RESPONSE TO COMMENTS

CERTIFICATE OF THE SECRETARY OF ENERGY AND ENVIRONMENTAL AFFAIRS
ON THE
DRAFT ENVIRONMENTAL IMPACT REPORT

PROJECT NAME : New Quincy Center Redevelopment
PROJECT MUNICIPALITY : Quincy
PROJECT WATERSHED : Boston Harbor
EOEA NUMBER : 14780
PROJECT PROPONENTS : City of Quincy/Hancock Adams Associates, LLC
DATE NOTICED IN MONITOR : May 9, 2012

Figure 8.1
 October 31, 2012
 Revere Road Stormwater Confluence
 Post Realignment Town Brook
 Final Environmental Impact Report
 New Quincy Center Redevelopment
 Quincy, Massachusetts

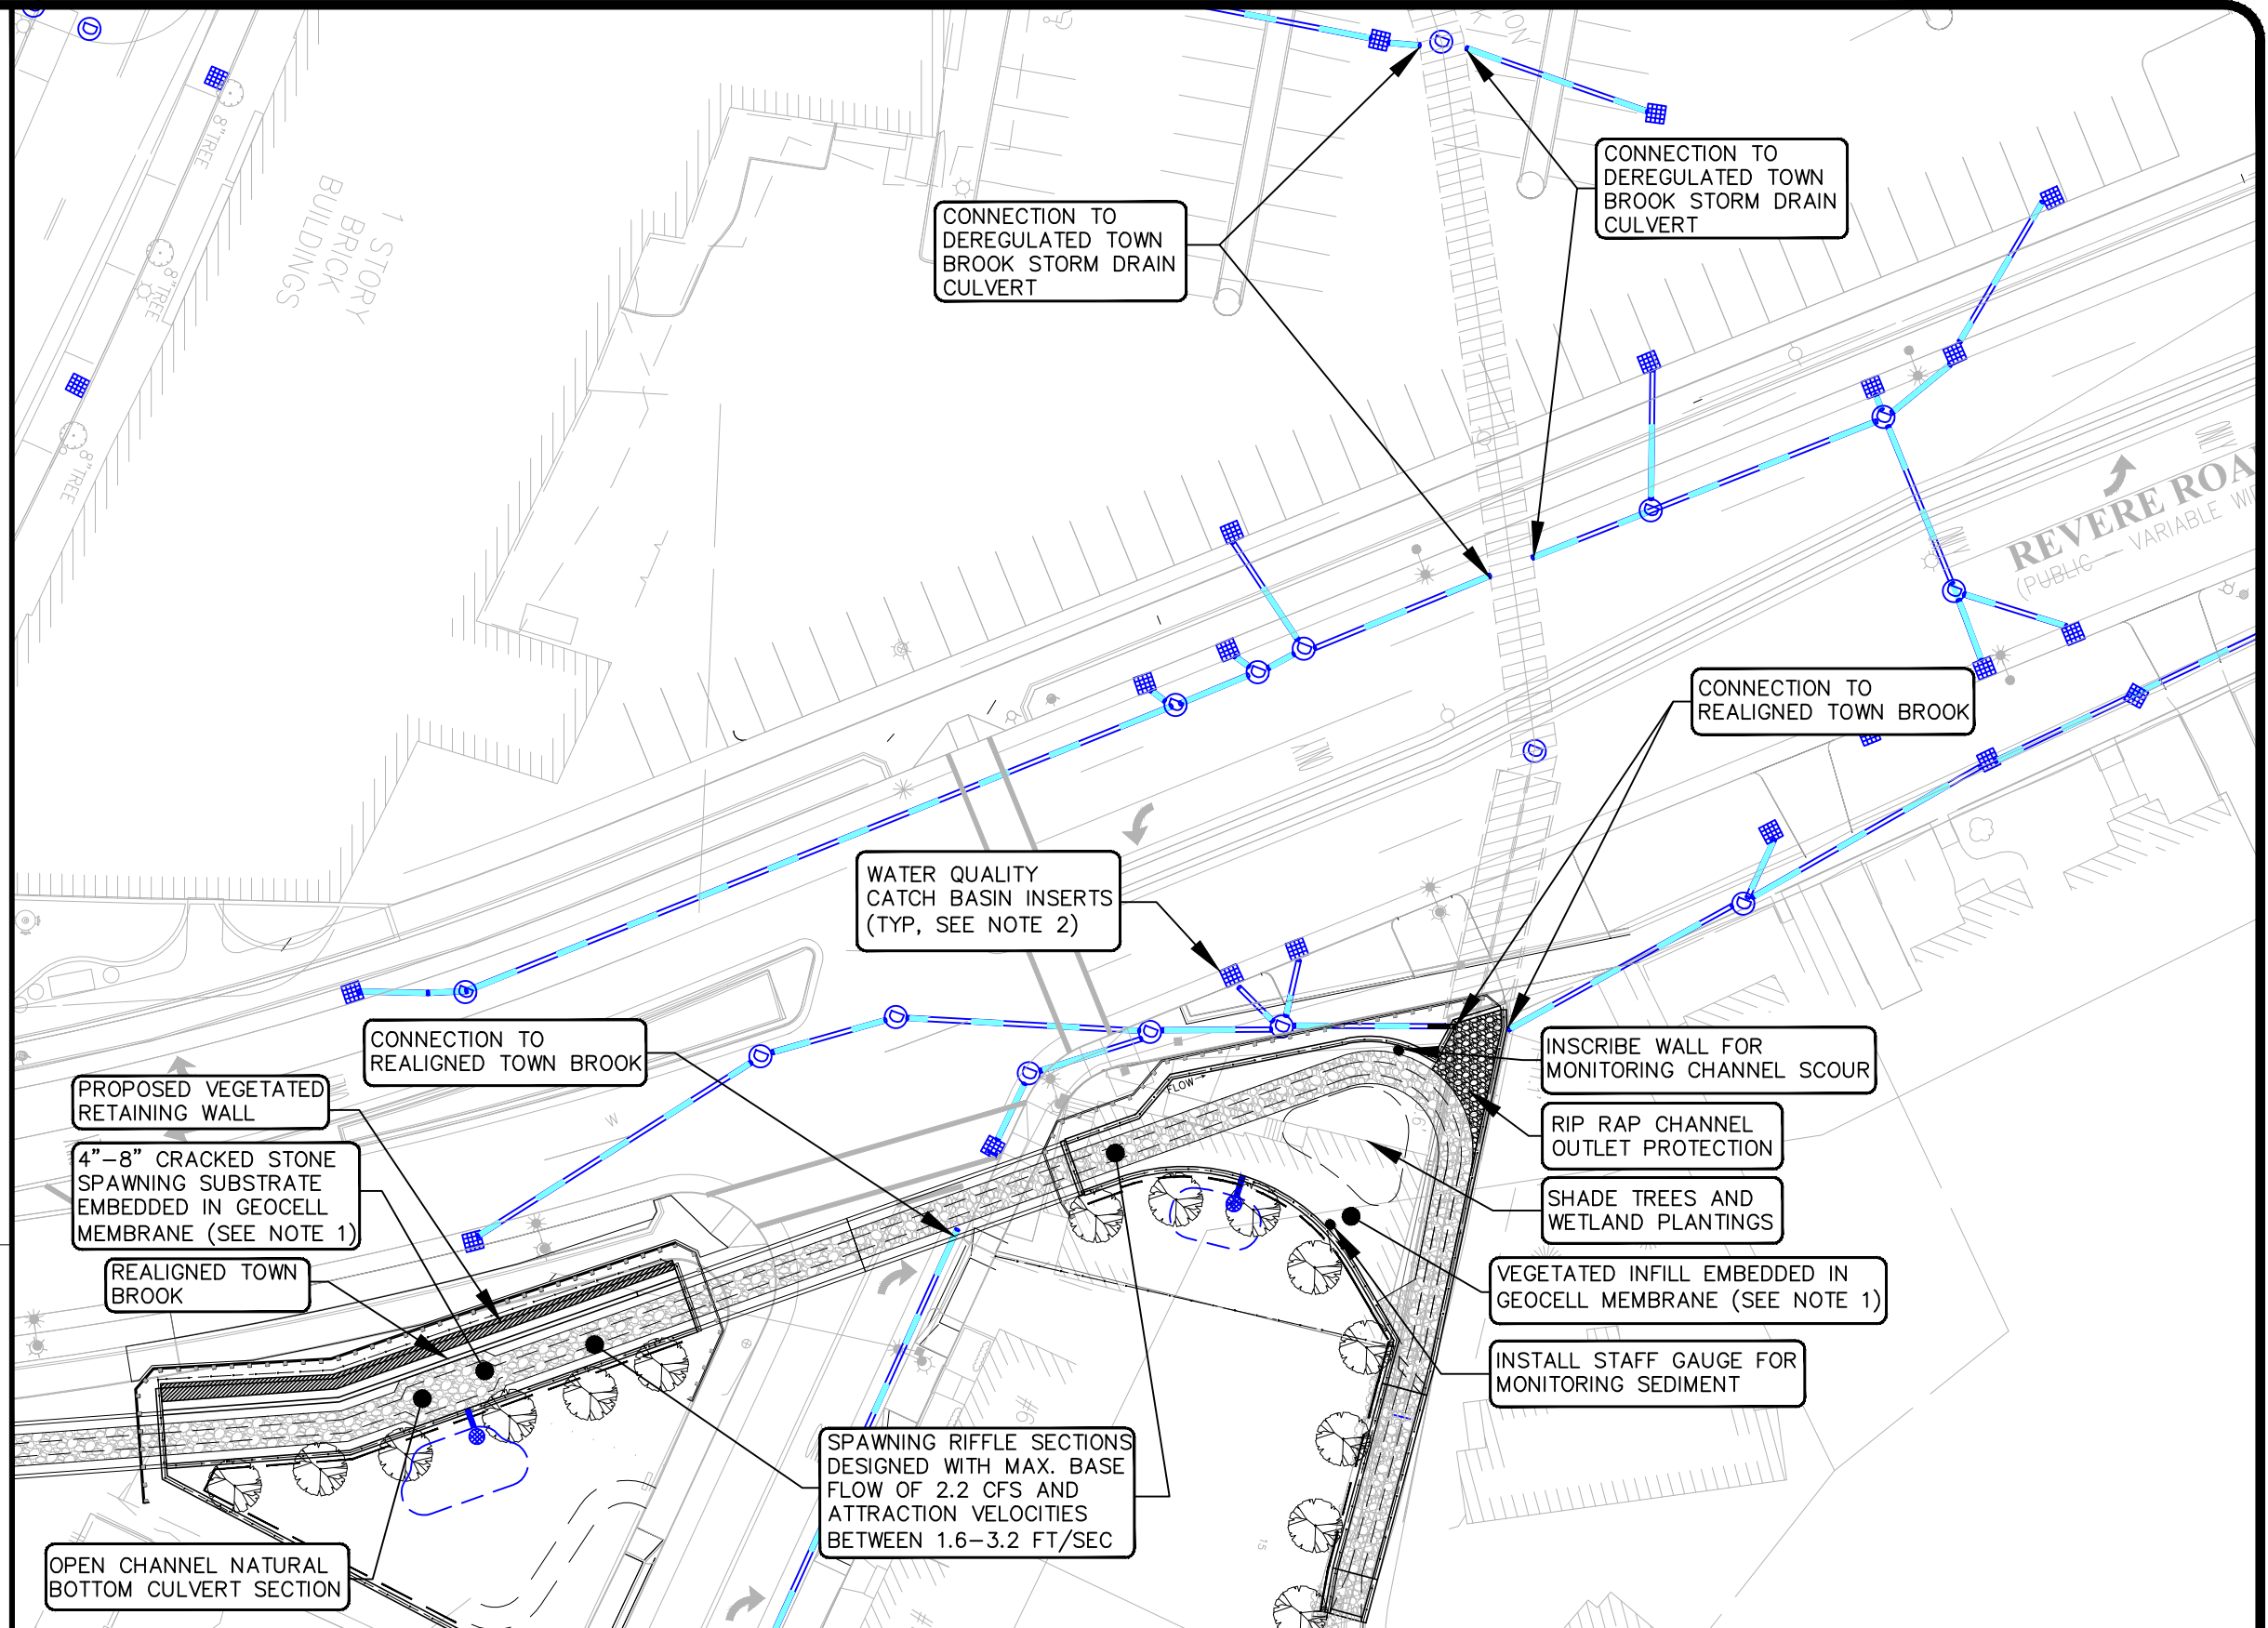
MEPA 05 The FEIR should address... the effects the project will have on stormwater base flows and peak flows, particularly for the proposed new discharge outfall at Revere Road that will consolidate many of the existing outfalls in the former Town Brook alignment into a single discharge point.

MEPA 09 **The FEIR should also include a revised plan and sufficient information for MassDEP to understand the proposed changes in the hydrology of Town Brook. The hydraulics of the proposed consolidated discharge through Revere Street outfall should be analyzed for erosion, sedimentation and backwater effects and any adverse effects should be minimized.**

The Project will not modify the conveyance of base flows or impact the total rate of base flows within the Project area, and the Project does not include any base flow modifications that would adversely affect the fish run. With completion of the separate Town Brook Enhancement Project, base flows from upstream reaches of Town Brook will be conveyed within the realigned Town Brook through 171 net new additional linear feet of enhanced open channel relative to existing conditions. Please refer to the Final EIR for the Town Brook Enhancement Project for a complete discussion of the impacts and mitigation associated with realignment and enhancement of Town Brook.

In addition, the proposed redevelopment Project will convey stormwater from within the Project area through a closed culvert system designed to the 25-year storm event. There will be no scour or erosion within the stormwater conveyance system within the Project area, and there will be no change to the stormwater peak rates of runoff of volumes when compared to existing conditions at the discharge to Town Brook at Revere Road. Section 2.2 contains an expanded discussion about stormwater.

The stormwater discussion in Section 2.2 and accompanying figures have been revised to clarify the hydrologic analysis for the Project and to provide the requested details regarding any Project effects on the Town Brook realignment as proposed by the Town Brook Enhancement Project. There will be no change to the stormwater peak rates of runoff or volumes when compared to existing conditions at the discharge to Town Brook at Revere Road. Section 2.2 contains an expanded discussion about stormwater.
